TECHNICAL MEMORANDUM

File No.: 3386-001.000 Task 15

Re: Pinnacle at Liberty Bay: Third-Party Review

PINNACLE AT LIBERTY BAY PRD

SITE MAP

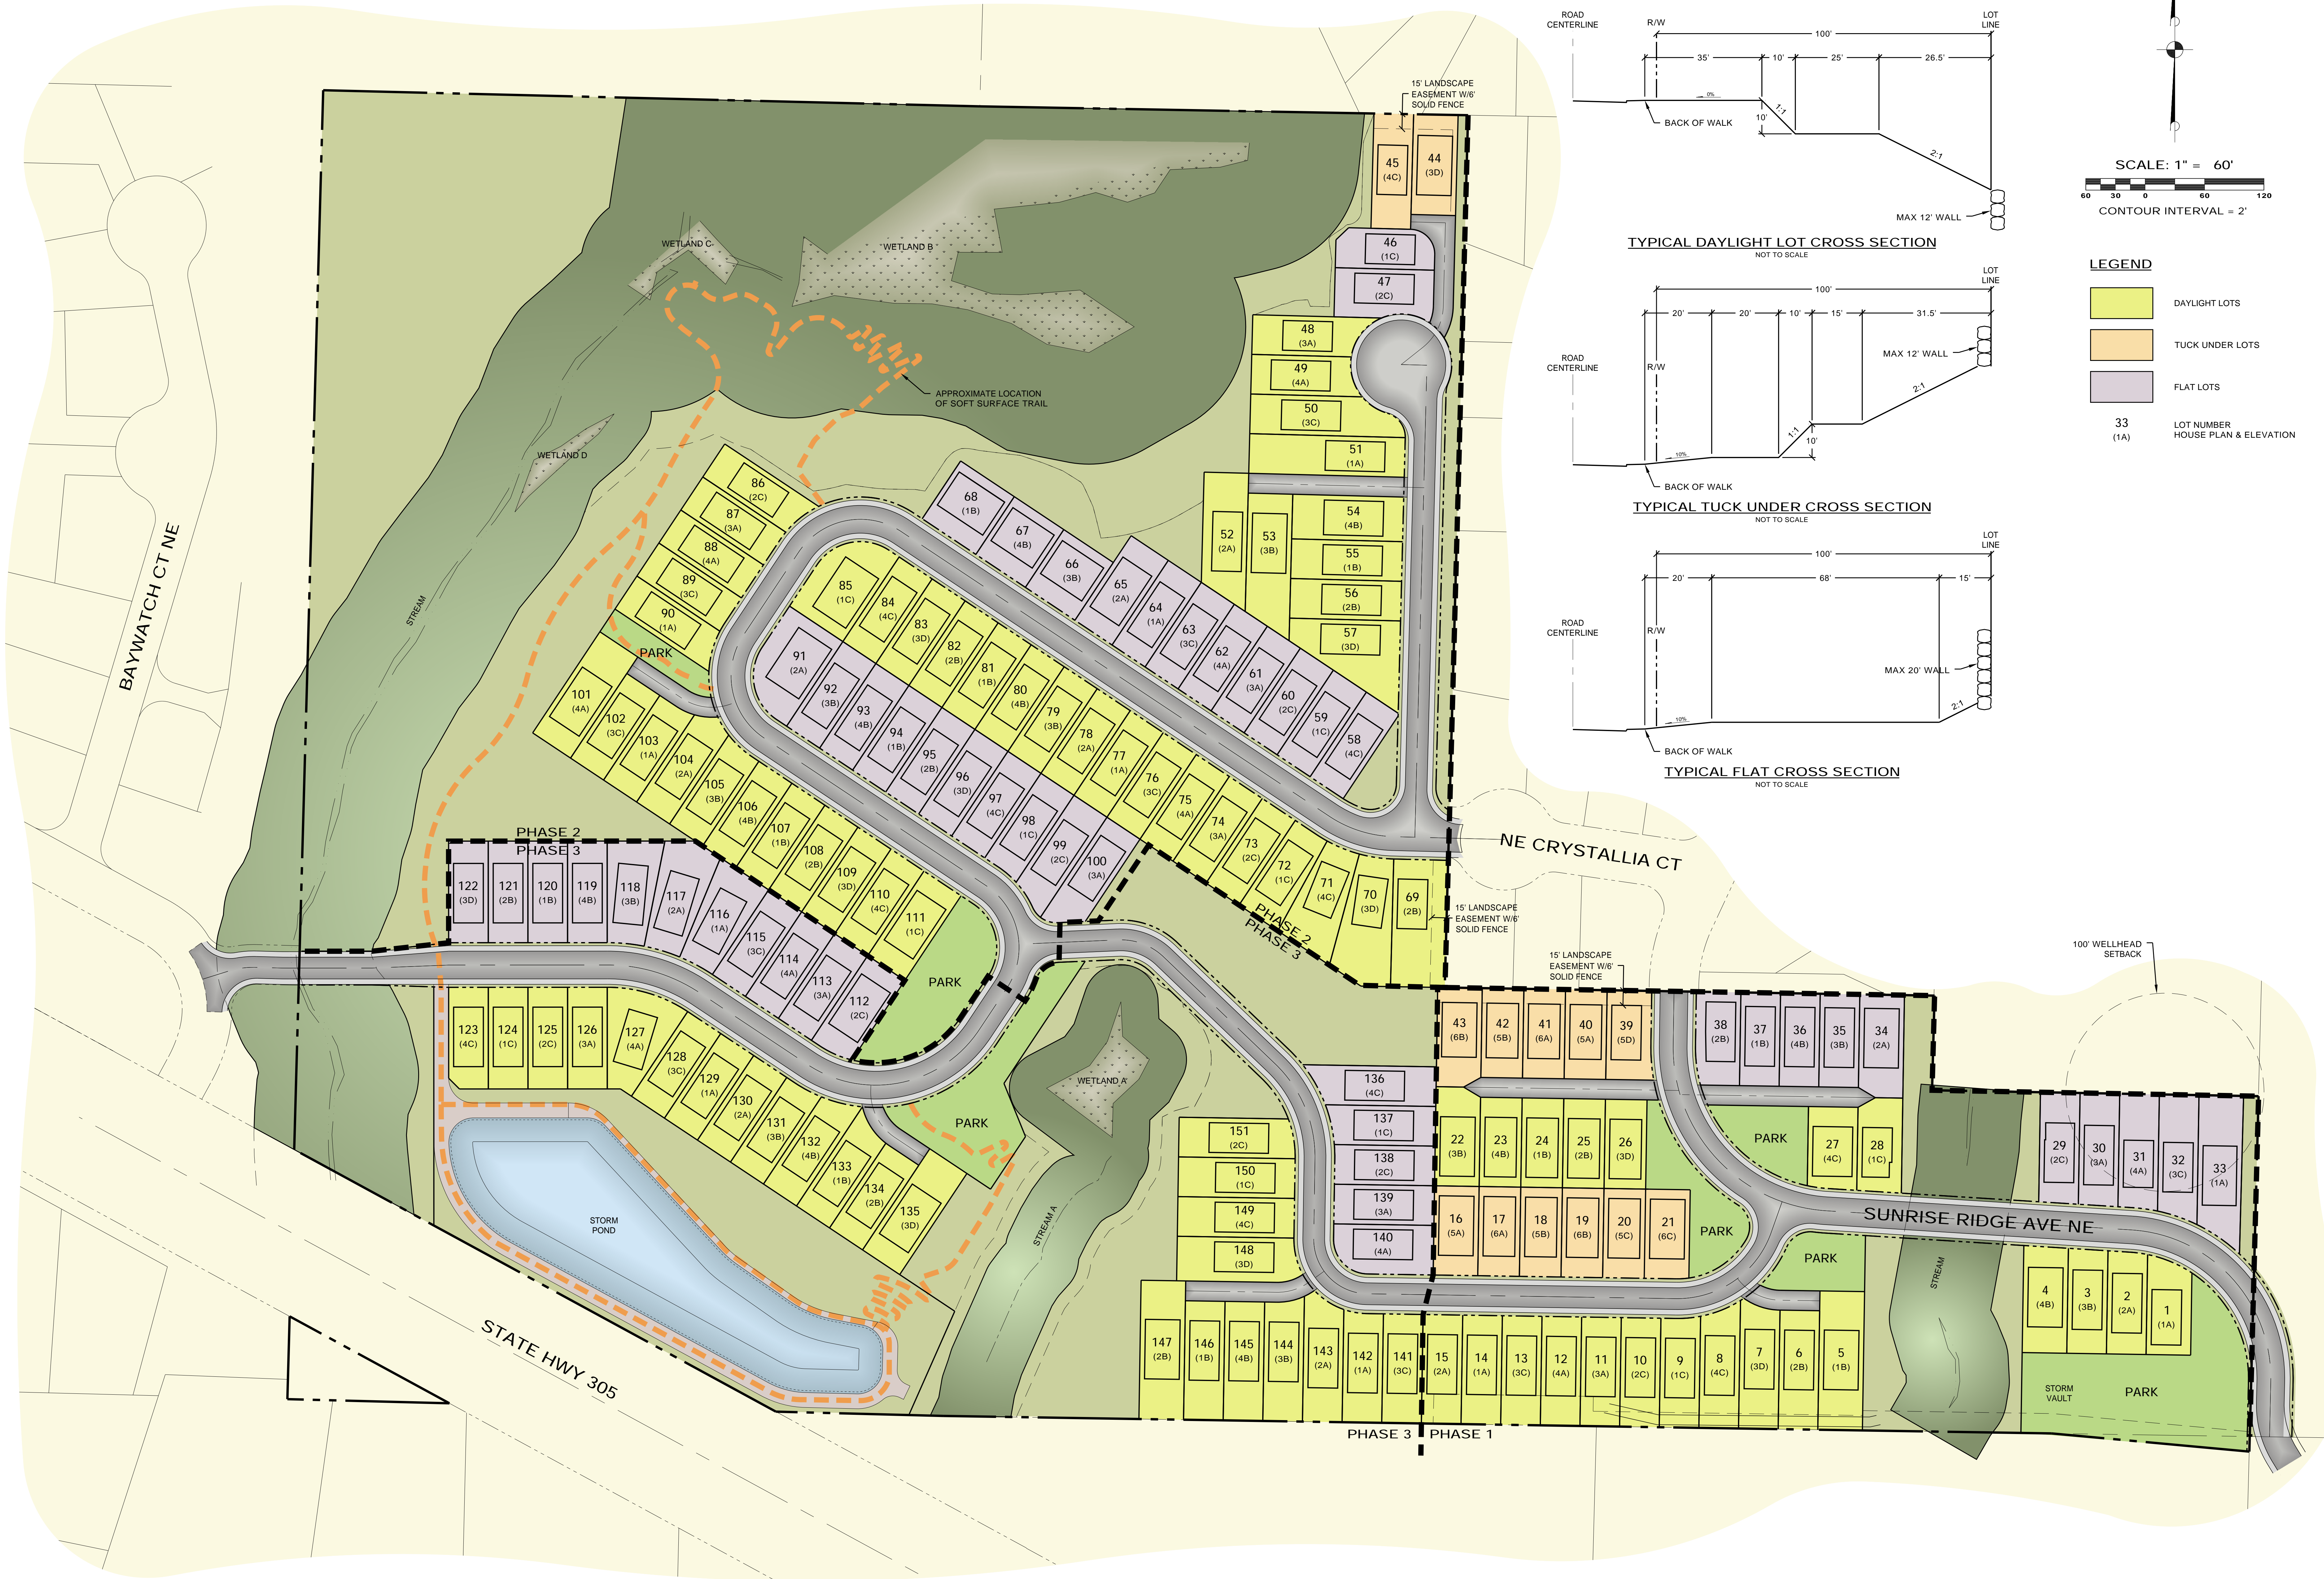
Grette traversed the project site to identify any wetlands or fish and wildlife habitat conservation areas (FWHCAs) on or within 300 feet. In summary, Grette concurs with the extent of wetlands (Wetlands A, B, C, and D) within the project site (Attachment 1); however, staff did identify a linear offsite feature east of Lot 33 and along Maple Hill Ave. NE that appears to have been flagged by SWC. The boundary of this feature was flagged and labeled consistently with the onsite wetland features but the Plan does not provide a discussion describing the status of this feature. Per PMC 16.20.220, all wetlands within 300 feet of a proposed project shall be identified. Two stormwater ponds were also identified in the southeast corner of the project site which are situated south of Lots 1 and 2. Per PMC 16.20.155, artificial wetlands, such as stormwater detention facilities, are not a regulated wetland feature.

In addition to the identified wetlands, Grette identified four streams (Streams A, B, C, and D) within the project site (Attachment 1). Grette largely concurs with the mapped locations of these features. However, based on the site assessment Stream B appears to flow into Wetland B, which is not clearly shown on the delineation map or site plans.
